COUNTY OF SANTA CRUZ

September 1, 2011

Agenda Date: September 14, 2011

Subject: Review of Olive Springs Quarry Operating Under Mining Approval 88-0233 for Compliance with Conditions of Approval, and Minor Amendment to the Mining Plans

PHOTOGRAPH OF NORTH SLIDE
Olive Springs Quarry
Santa Cruz County, California
Mining Approval 88-0233
photo date: 4 March 2010

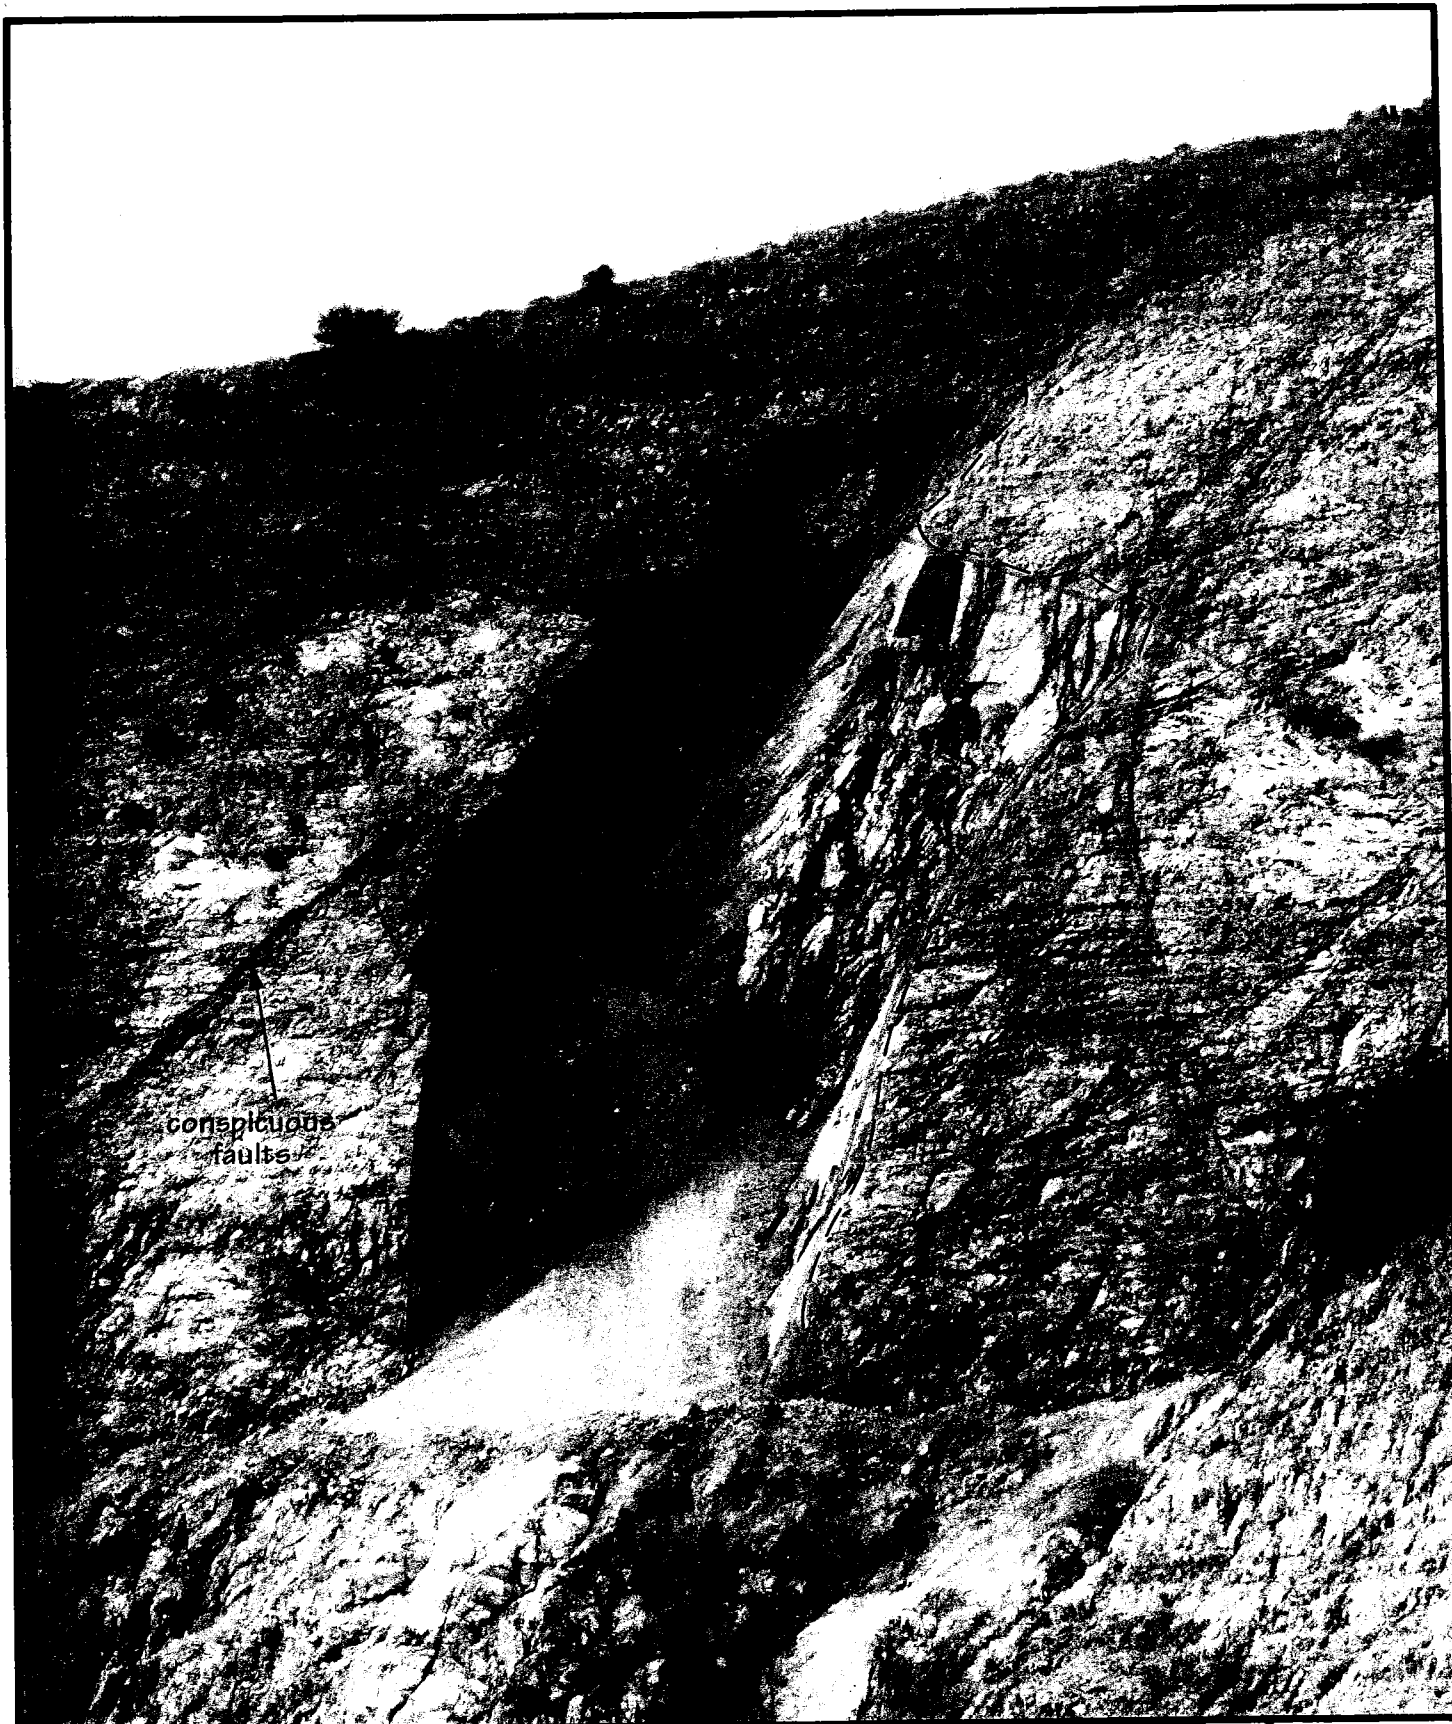
During the weekend of 6-7 February 2010, two large slides occurred on the working face of the quarry. These slides have subsequently enlarged in a piecemeal fashion. We inspected the working face of the quarry on 11 February 2010 with quarry staff and Gary Ifland of Ifland Survey, the project surveyor. We performed follow-up inspections on 4 and 30 March, and 18 May 2010. The slide area consists of a North Slide on the tallest portion of the working face, and a smaller South Slide immediately to the south (Figure 1; 2010 Aerial Photograph of Quarry and Figure 2; Photograph of Slide Area). During our inspections, we noted that the slide areas were limited to the active working face of the quarry and occurred entirely within the granitic rock comprising the quarry face. The failures likely toe at the base of the working face along a narrow bench with the slide deposits burying the bench and extending down onto a wide bench above the quarry floor. Photographs of the North and South slides appear on Figures 3 and 4, respectively.

which there may be a color contrast or along which the crushed granite has been eroded from (Figures 3 and 4). Groundwater seeps are present along some faults. The faults or shears are related to the main trace of the Zayante Fault which trends northwest-southeast through the quarry property (Figure 1). Although the dominant orientation of shears trend northwest and dip steeply to the southwest, many shears trend southwest into the working face and dip steeply to the southeast. The shears are planes of weakness across which there is little to no cohesion of the granitic rock. Most of the failures have occurred on and are bounded by these faults or shears.
